TSB 2016-1002 Level: 2

Topic	Overtightening of 4-in-1 Ball Valve Tool (Core Removal Tool) can lead to failure and potential venting of the system under service.
Affected Units	4-in-1 Ball Valve Tool, All Models
Resolution	This tool should be tightened by hand only as shown in procedure below.

Figure 1

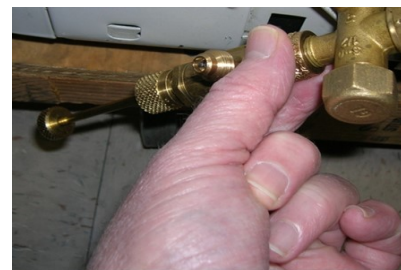
1. ASSURE PROPER ALIGNMENT AND ACCESS TO THE SIDE PORT AND VALVE HANDLE BEFORE TIGHTENING THE TOOL (Figure 1)
